SERVICE LETTER SL44 66-12107 Rev A

66-12107 SPACER, FWD FUSELAGE FITTING, AEROCET MODEL 6650 FLOAT INSTALLATION, KODIAK AIRCRAFT

66-12107 ISOMETRIC VIEW

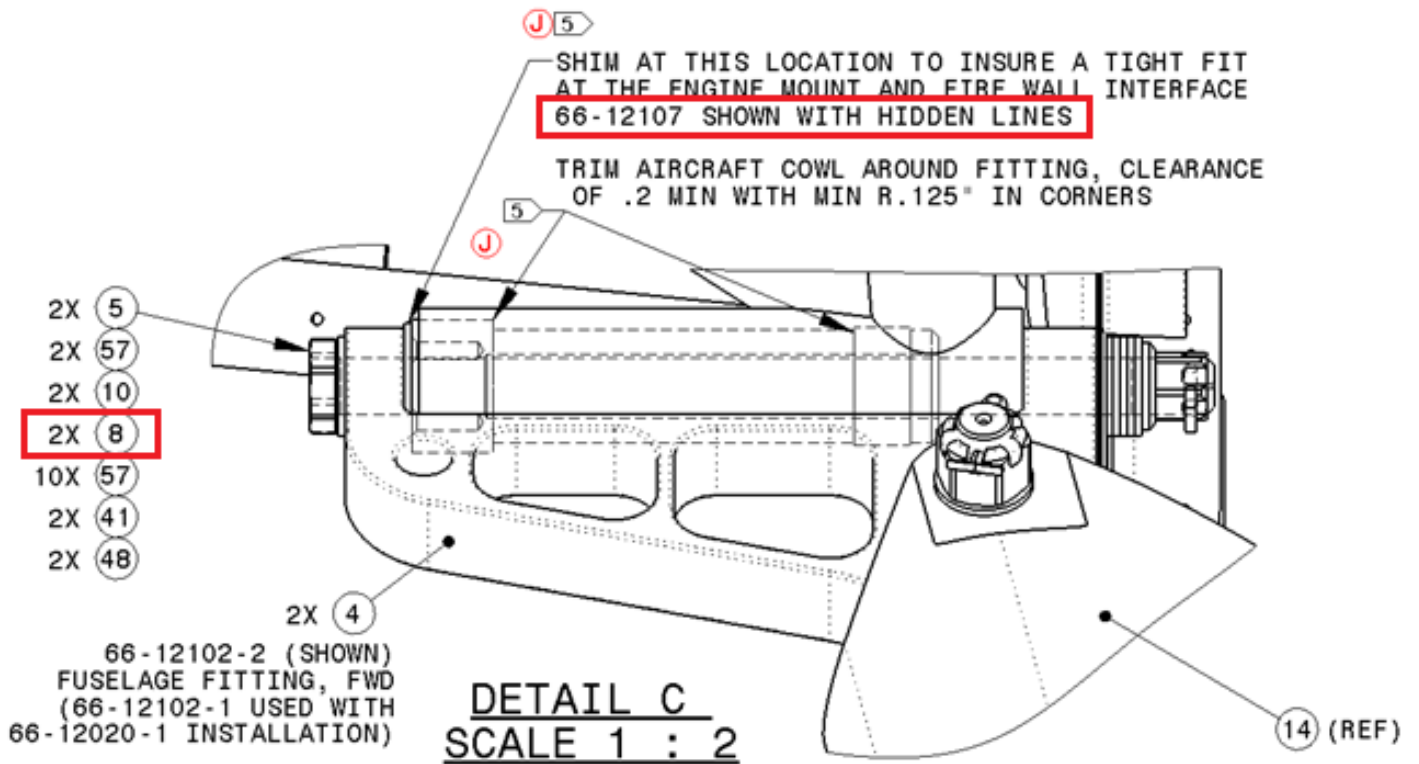
1. **Release Date:** 08/30/2018
2. **Service Letter No.:** SL44 66-12107
3. **Reason for Change:** Tolerance stacking between the Aircraft and the float installation parts is causing an installation difficulty.
4. **Part/Assembly No.:** 66-12107
5. **Float Model Affected:** 6650 and 6750
6. **Disposition of Product in Field:** NA
7. **Approval:** All information provided is in accordance with approved data.
8. **Corrective Action:** Informational Only (See additional verbiage below)
9. **Time Required:** NA
10. **Payments to customer:** None. Call (208) 448-0400 for Parts Department

To accommodate the tolerance of the engine mount, Aerocet redesigned the 66-12107 spacer, ultimately manufacturing them in three different outside dimension sizes. The -1 is the smaller of the spacers and the -3 is the largest.

Existing parts in the field that were previously installed can still be used *as long as they do not conflict with the engine mounts and pass a visual inspection for excessive wear and damage.*

The installer or mechanic is to use the largest dash number (66-12107-1 through -3) that will fit inside the engine mounts.
